APPENDIX H. Road Safety Audit and Designer's Response

Road Safety Audit Report

Proposed Roundabout along the A325
Holt Pond

Report Title:	Stage 1 Road Safety Audit
Date:	December 2023
Document reference and revision:	RSA-23-140-4
Prepared by:	Fenley Road Safety Limited
On behalf of the Overseeing Organisation:	Hampshire County Council
Design Organisation:	i-Transport
Project Sponsor:	Haskins Garden Centre

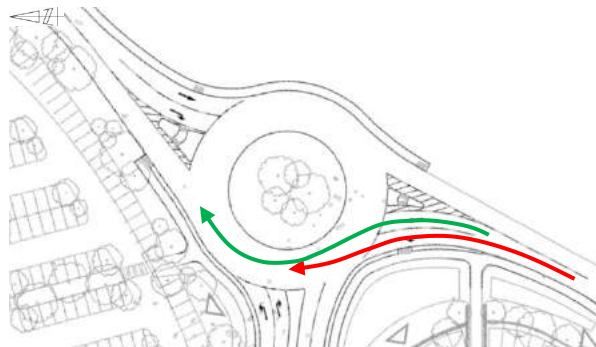
A.3.1 PROBLEM

Location: Northbound approach

Summary: Straight ahead traffic is required to utilise Lane 2 on approach to the roundabout

The proposals include the provision of a three-arm roundabout along the A325 which is to allow access to a redeveloped garden centre and wildlife attraction. The proposed roundabout junction consists of a 44 metre inscribed circle diameter with a 26 metre diameter central island generating a 9 metre circulatory carriageway. Whilst a two-lane exit is to be provided along the proposed

access arm, the A325 exits are to consist of single lane merges with a bus stop provided on the southbound exit where traffic should not be travelling at high speed and an area of central hatching is provided which optimises forward visibility should a vehicle wish to overtake. Two-lane approaches are provided on each arm which are designated via arrow road markings just in advance of the give-way lines. At roundabouts with two lane entries, the nearside lane (Lanes 1) is generally utilised by straight ahead traffic as well as left turning traffic while the offside lane (Lane 2) is utilised by vehicles continuing straight. Whilst the circulatory carriageway is adequate for two lanes of traffic and the physical width of the exits should allow for merges, the Audit Team is concerned that northbound traffic continuing straight ahead, is likely to utilise the nearside left turn lane which could lead to sideswipe type collisions on the circulatory.

It is recommended that measures are provided to encourage the use of the offside lane (Lane 2) for straight ahead eastbound traffic

Agreed - Road markings could be introduced on approach to the roundabout to direct drivers toward the offside lane unless turning left. This would position drivers travelling ahead in the offside lane by default. The road markings will be considered further at detailed design stage. Furthermore, signing will be provided in line with TSRGD providing directional and lane signage.

Confirmation that road markings will be considered during the detail design stage to encourage traffic to approach in Lane 2, addresses the road safety concern raised at this stage.

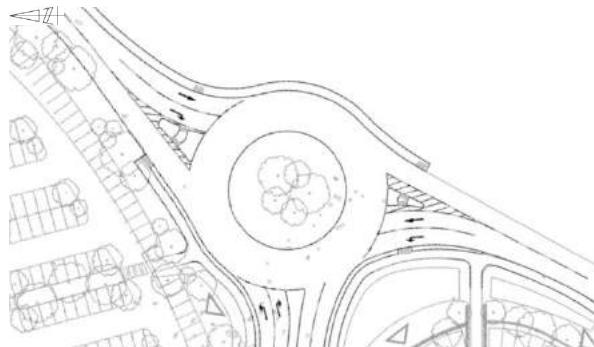
A.3.2 PROBLEM

Location: A325

Summary: The proposed junction may not be clearly visible to approaching traffic

The A325 is a single carriageway two-way road that is subject to a 50mph speed limit and rises from south to north before levelling out in proximity to the existing Haskins Garden Centre with a

crest present just to the south of the existing access. The proposals include the provision of a 44 metre ICD roundabout along the A325 in the vicinity of the crest. The scheme drawings provided with the Audit Brief, detail that forward visibility is achievable in accordance with the 85th percentile speeds observed, which comply with the speed limit of the road, over a distance of 1.5x the SSD. This level of visibility will allow the majority of road users to become aware of the proposed roundabout, however, the Audit Team have concerns that not all road users will become aware of the junction ahead at a safe distance which could lead to loss of control and overshoot type collisions.

It is recommended that measures are provided to ensure adequate warning of the junction ahead is achievable.

Agreed – Street lighting and advanced directional signage will be provided in accordance with HCC requirements along with reflective bollards and appropriate signage, which will be clearly visible from far in excess of the 160 metre forward visibility envelopes illustrated. Therefore, all road users will become aware of the junction at a safe distance

Confirmation that measures will be provided to ensure that all approaching users become aware of the junction at a safe distance, addresses the road safety concern raised at this stage.

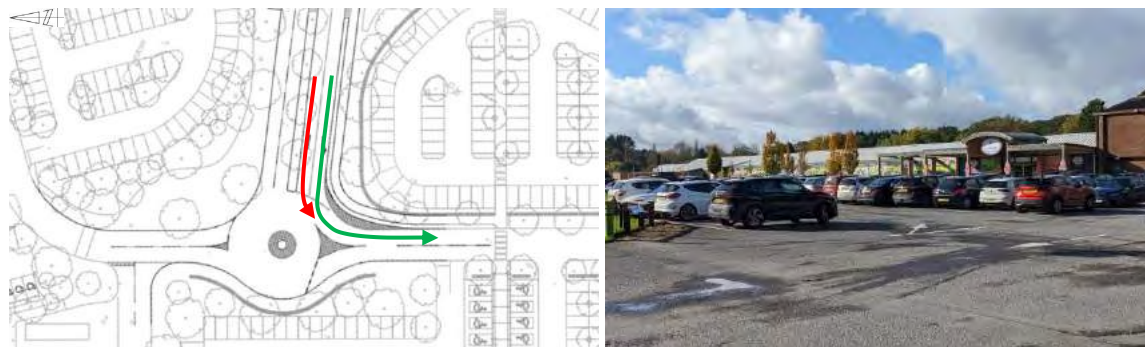
Location:	Proposed mini-roundabout
Summary:	No lane designation signage is provided
Acc Type:	Sideswipe type collision

The proposals include the on-site highway associated with a proposed redevelopment of Haskins Garden Centre as well as Birdworld and consists of a small section of two-lane dualled carriageway between the A325 and a mini-roundabout serving two separate parking facilities. The scheme drawing illustrates that the lanes on approach to the mini-roundabout are to be designated

and that the ghost splitter island on the southern arm is to extend into the circulatory to force traffic in the nearside lane, to enter the proposed garden centre parking facility. The Audit Team have concerns that approaching drivers / riders won't become aware of the lane designation at a safe distance which could result in late lane changes and sideswipe type collisions.

It is recommended that measures are provided to ensure that road users become aware of their route ahead.

Agreed – Directional signage will be provided and assessed through the detailed design of the scheme.

Confirmation that the signage will be provided, addresses the road safety concern raised at this stage.

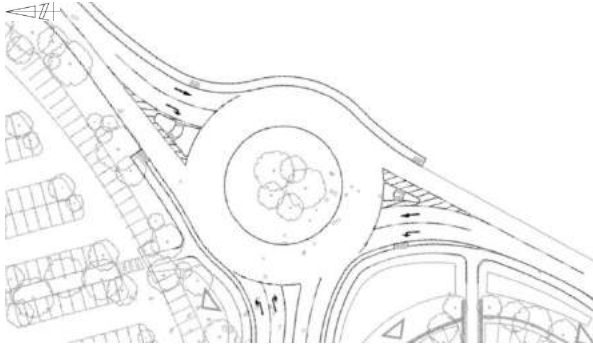
<p>Location Plan:</p>  	
<p>DESIGN ORGANISATION RESPONSE provided by i-Transport on the 5th December 2023 following formal issue of this Stage 1 Road Safety Audit on the 7th November 2023</p>	
<p>Agree – The boundary of Alice Holt Forest is offset from the A325 carriageway by circa 7 metres and therefore ample space is present to provide a margin besides the carriageway, the illustrated footway and footway cycleway and a sufficient embankment which accords with guidelines.</p>	
<p>AUDITOR’S VIEW OF DESIGN ORGANISATION RESPONSE dated 20th December 2023</p>	
<p>Confirmation that an adequate embankment will be provided, addresses the road safety concern raised at this stage.</p>	
A.4.3	PROBLEM
Location:	Proposed roundabout
Summary:	Cyclists accessing the site, would be required to negotiate the roundabout
Acc Type:	Vehicle to cyclist and pedestrian collisions
<p>The A325 allows access to the Haskins Garden Centre and Birdworld attraction via simple priority junctions off the western side of the carriageway. The proposals include the stopping up of the access to the Garden Centre and provision of a three-arm roundabout which is to serve both the redeveloped Garden Centre and Birdworld. The documents provided with the Audit Brief detail that a ‘greater provision of cycle parking is to be included within the proposals’ and therefore it can be assumed that cyclist trips are likely to increase which could include the young and those with less experience. Whilst cyclists can safely manoeuvre at a roundabout which accommodates two lane approaches, the Audit Team have concerns that young and less experienced cyclists may not confidently navigate the junction which could lead to vehicle to cyclist type collisions.</p>

<p>RECOMMENDATION:</p>	
<p>It is recommended that the proposed footway and crossing facilities are upgraded to accommodate cyclists to allow for the junction to be bypassed.</p>

<p>Location Plan:</p>  	
<p>DESIGN ORGANISATION RESPONSE provided by i-Transport on the 5th December 2023 following formal issue of this Stage 1 Road Safety Audit on the 7th November 2023</p>	
<p>Agree – The design has been revised to provide cycle on / off-slips pedestrian and cycle crossing facilities to allow the junction to be bypassed with the 2 metre footway graded to provide a 3.0 metre shared footway cycleway. Appropriate corduroy paving has been provided to denote the end/start of shared surface. This is shown on Drawing ITB16329-GA-106 revision C and has resulted in the minor relocation of the junction, circa 0.5 metres further northwest.</p>	
<p>AUDITOR'S VIEW OF DESIGN ORGANISATION RESPONSE dated 20th December 2023</p>

<p><i>Confirmation that the proposed footway has been widened and upgraded will provide a safe route for cyclists and addresses the road safety concern raised at this stage. The minor relocation of the junction raises no further road safety concerns.</i></p>	
A.5	TRAFFIC SIGNS, CARRIAGEWAY MARKINGS AND LIGHTING
A.5.1	PROBLEM
Location:	Proposed roundabout
Summary:	Traffic may attempt to turn right onto the circulatory
Acc Type:	Head-on type collisions
<p>The proposals include the provision of a 44 metre ICD roundabout along the A325 which accommodates two lane entries and is to allow access to a redeveloped Haskins Garden Centre as well as Birdworld attraction. The scheme drawing provided with the Audit Brief, illustrates that directional arrow road markings are to be provided on the approach to the give-way lines. Whilst the provision of arrow road markings provide guidance as to the route ahead, the Audit Team have concerns that right turn arrow markings on the approach to a roundabout, could encourage traffic to turn right onto the circulatory which could lead to head-on type collisions. This is of particular concern due to the likelihood of the redevelopment attracting foreign road users.</p>

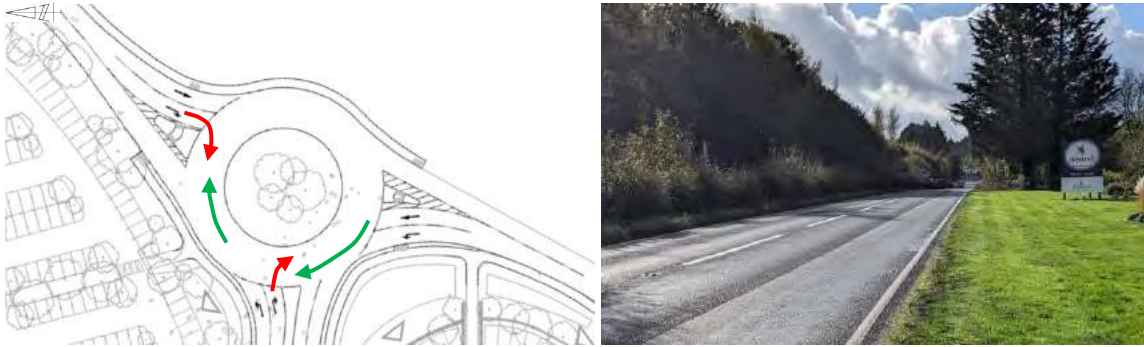
<p>RECOMMENDATION:</p>	
<p>It is recommended that chevron signs are provided.</p>

<p>Location Plan:</p> 	
<p>DESIGN ORGANISATION RESPONSE provided by i-Transport on the 5th December 2023 following formal issue of this Stage 1 Road Safety Audit on the 7th November 2023</p>	
<p>Agreed – Chevron signs will be provided on the central island to highlight the clockwise nature of the circulatory and to deter traffic turning right onto the circulatory. The road markings will be further assessed in consultation with Engineers from Hampshire County Council through the detailed design approval process.</p>	
<p>AUDITOR’S VIEW OF DESIGN ORGANISATION RESPONSE dated 20th December 2023</p>	
<p>Confirmation that chevron signs will be provided on the central island should deter approaching vehicles from attempting to turn right and therefore, addresses the road safety concerns at this stage.</p>	
A.5.2	PROBLEM
